Project No. 3030684-LU

City of Seattle Response to Guidelines: MUP Application for Design Review

(See below Diagram of requested departure)

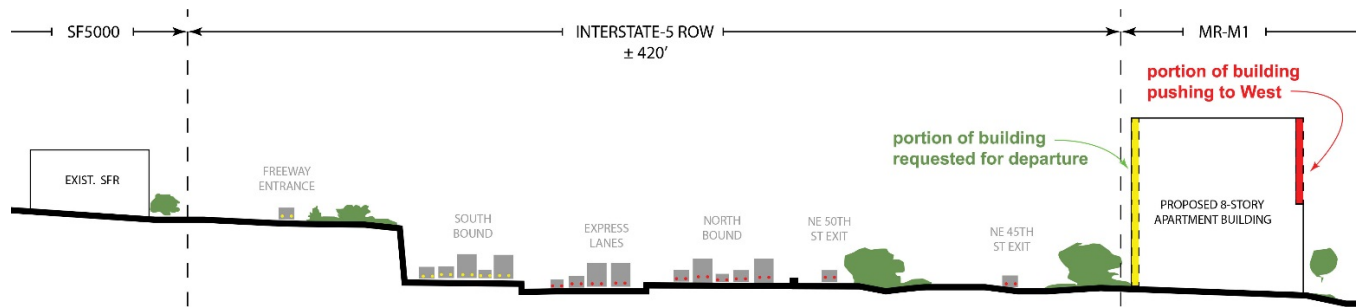
1. Rear setback reduction (23.45.518, Table B): The Code requires an average of 7 ft setback with a 5 ft minimum above 42 ft and a 10 ft average setback with 7 ft minimum below. The applicant proposes that the setback be reduced to 5 ft below 42 ft and 5 ft above with a 7 ft average.

Staff supports the requested departure. Moving mass away from the front of the building supports a human scale street frontage along 7th Ave. Pushing the mass to the rear of the site has little negative impact since its backs on to a busy freeway. The proposal makes use of this allowance to create a strong, prow-like visual presence that is scaled to the passing freeway and meets guidelines pertaining to architectural character and design concept. (CS 2 and DC 2)

The departure is requested to reduce the western side setback above and below 42 feet. And for the set back below 42 feet to be reduced from 7 foot average / 5 foot minimum to 5 feet. At 42 feet and above asking to reduce from 10 foot average / 7 foot minimum to 7 foot average / 5 foot minimum. This departure allows the upper four stories of the building to essentially shift to the west without the loss of floor area, increasing the setback along 7th Ave NE above 42 feet. The larger setback on 7th helps to reduce the bulk of the building by stepping back from the street creating a four story podium which better responds to the scale of the adjacent buildings. In general we feel that a stepped setback can be more effective at responding to the neighborhood context along the street than at the i5 corridor which has no pedestrian experience.
